# Groundwater Transfer Review Summary Form

Transfer/PA # T- 14800 (RA)

Application: T-14800

Applicant Name: Fee Stubblefield

**Theis Drawdown Analysis – UMAT 332 Interference with UMAT 56889****Theis Time-Drawdown Worksheet** v.5.00

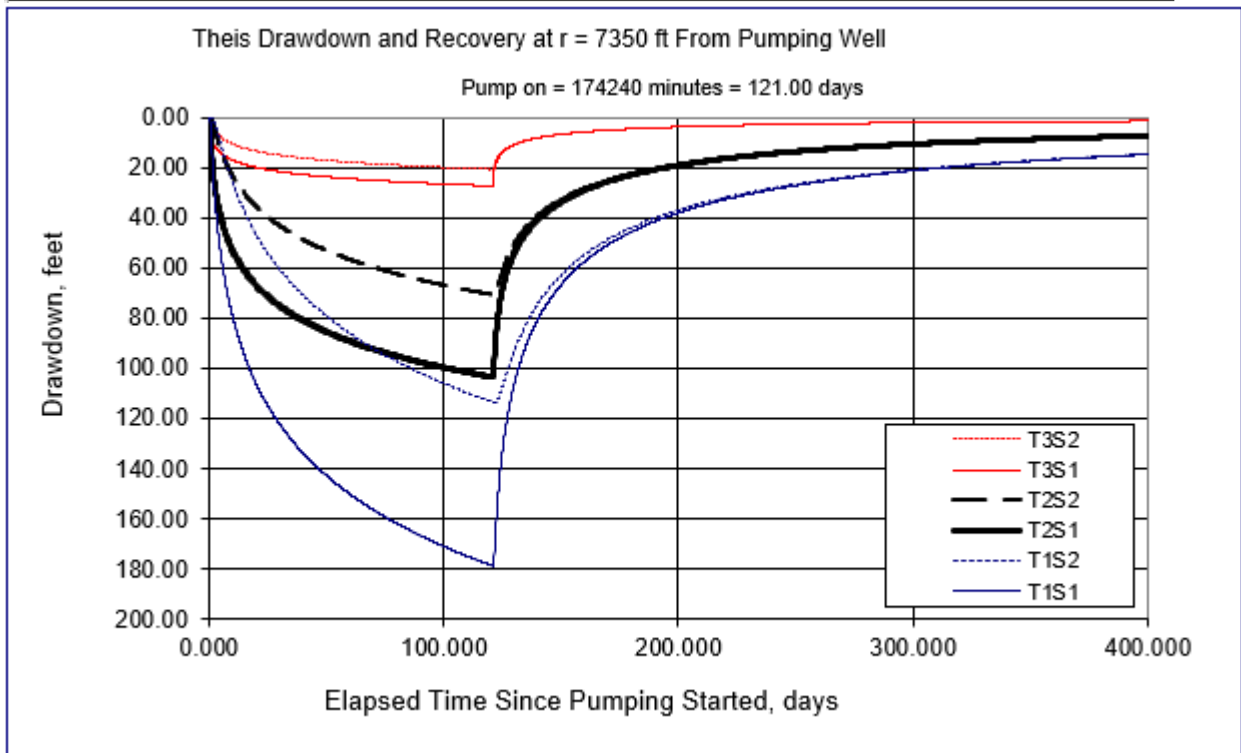
- b) If yes, would this proposed change, at its maximum allowed rate of use, likely result in another groundwater right not receiving the water to which it is legally entitled?  
☐ Yes ☒ No If yes, explain: The potential for Substantial or Undue Interference (SUI) per OAR 690-008-0001(8)(c) with UMAT 56889 and UMAT 327 due to the proposed changes was assessed using the Theis (1935) solution for drawdown in a confined aquifer (see attached Theis Drawdown Analysis). Hydraulic parameters used for the analyses were derived from regional data and studies (Pumping Test Reports; Norton & Bartholomew 1984, Zwart 1990) and are within the typical range of values for the hydrogeologic regime (Freeze and Cherry, 1979). Results indicate that SUI with nearby wells is unlikely under the proposed changes even if the proposed APOAs were pumped at their maximum combined rate until reaching the maximum duty under all authorized and proposed water rights. It is unlikely that the proposed APOAs could yield the maximum combined rates allowed under the proposed changes so the actual interference would likely be less than what is shown in the attached Theis Drawdown Analyses. The proposed changes are unlikely to deprive another groundwater right of water to which it is legally entitled.

**Theis Drawdown Analysis – UMAT 56683 Interference with UMAT 327****Theis Time-Drawdown Worksheet** v.5.00

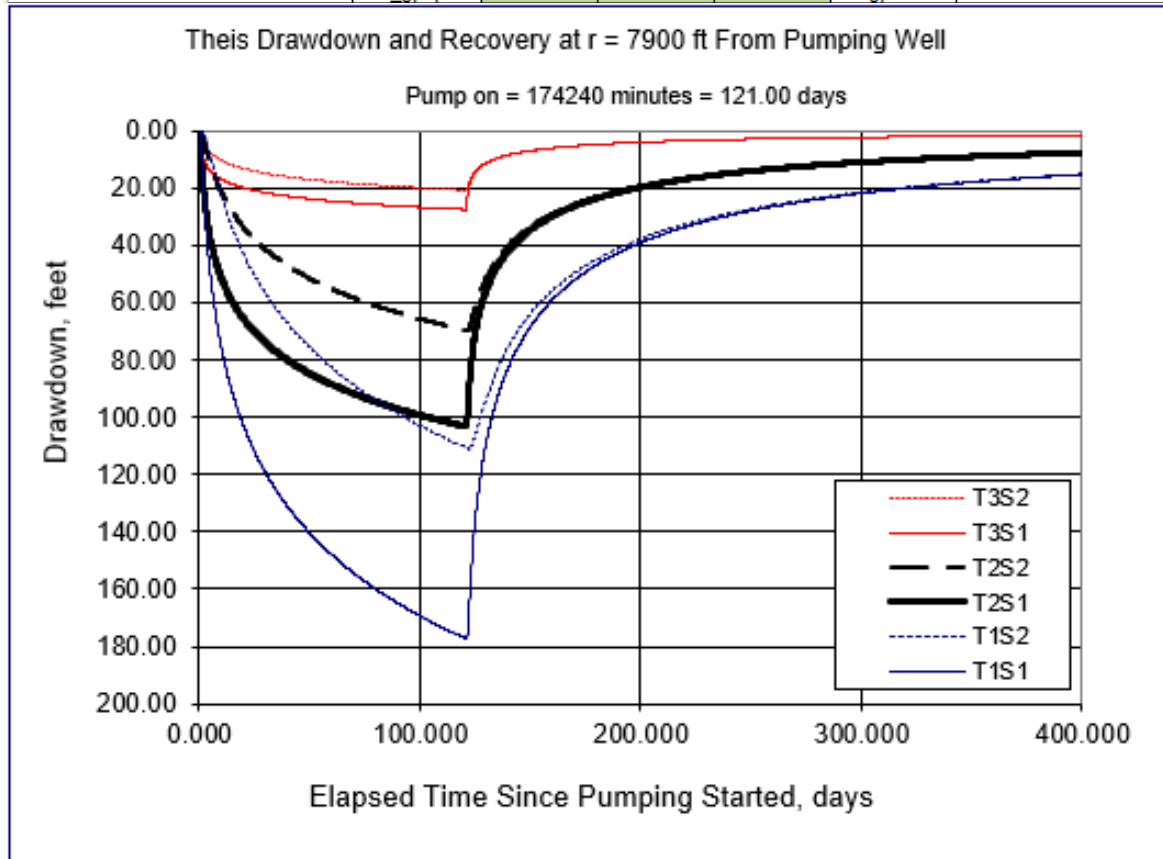
5. a) Will this proposed change, at its maximum allowed rate of use, likely result in an increase in interference with **another ground water right**?  
☒ Yes ☐ No Comments: The proposed APOAs are located considerably closer to nearby groundwater rights and domestic wells than the authorized POAs. Proposed APOAs UMAT 332 and UMAT 333 are 7,350 and 6,130 feet north of domestic well UMAT 56889, respectively, compared to 21,700 feet for UMAT 310 (authorized POA under Cert 57137). Similarly, proposed APOA UMAT 56683 is approximately 7,900 feet west of well UMAT 327, compared to 24,600 feet for UMAT 333 (authorized POA under Cert 84234). These reduced intervening distances would result in increased interference with the neighboring wells.

**Hydrograph** – Annual-high water levels for proposed APOAs. Permit decline condition trigger levels for UMAT 332 (Certificate 94333) and UMAT 56683 (Permit G-16610) are shown as dashed lines.

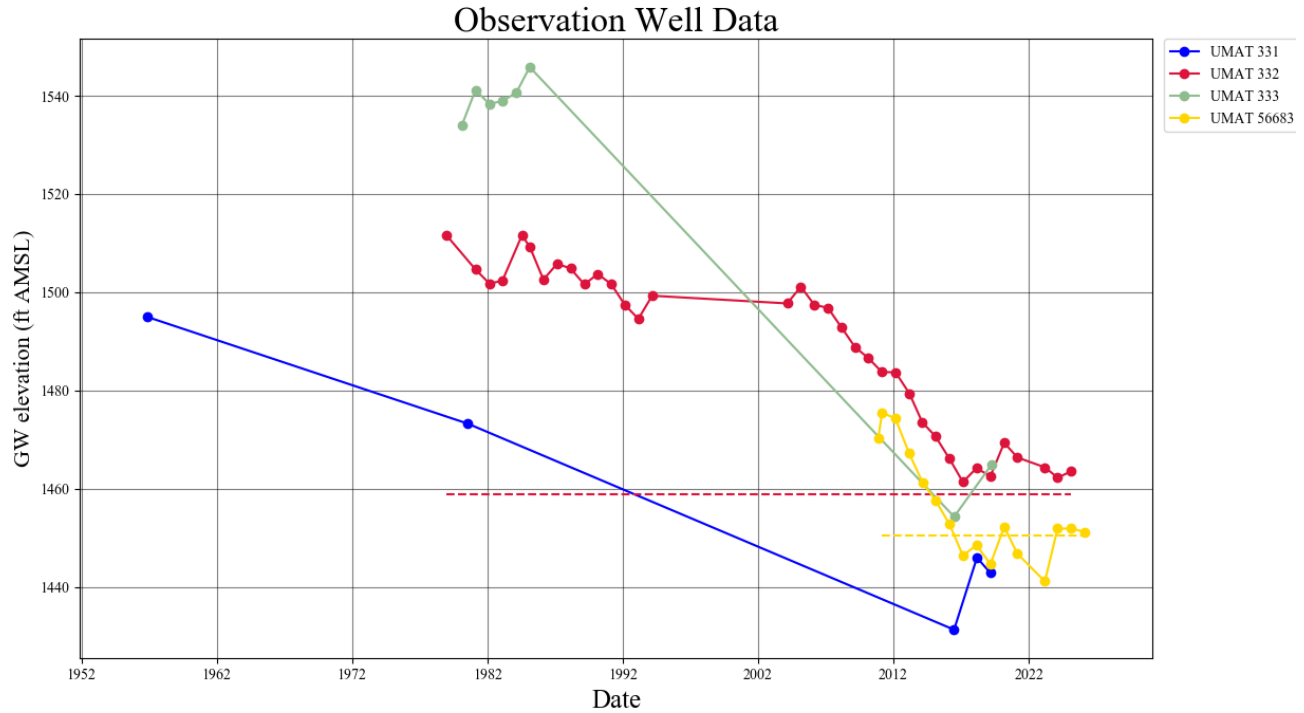
2. Will the proposed POA develop the same aquifer (source) as the existing authorized POA?  
☒ Yes ☐ No Comments: The authorized POAs and proposed APOAs all produce from multiple water-bearing zones of the Grande Ronde Formation of the Columbia River Basalt Group (CRBG). Static water levels in the authorized POAs and proposed APOAs are similar in elevation and show similar trends, indicating the wells develop the same aquifer (see attached Hydrograph).

9. Any additional comments: UMAT 332 and UMAT 56683 are subject to water level decline conditions under Certificate 94375 and Permit G-16610, respectively, neither of which is subject to this transfer. These conditions require the water user to reduce or discontinue pumping if annual measurements show a cumulative water level decline of 25 feet or more. To date, water levels have declined 20.21 feet at UMAT 332 and 24.23 feet at UMAT 56683 (see attached hydrograph), placing both wells within 5 feet of their respective trigger thresholds. The proposed changes would substantially increase the maximum rate that may be pumped at these wells and at the nearby proposed APOAs, which may accelerate water level declines and lead to curtailment of water use under Certificate 94375 and/or Permit G-16610 if the 25-foot thresholds are exceeded.
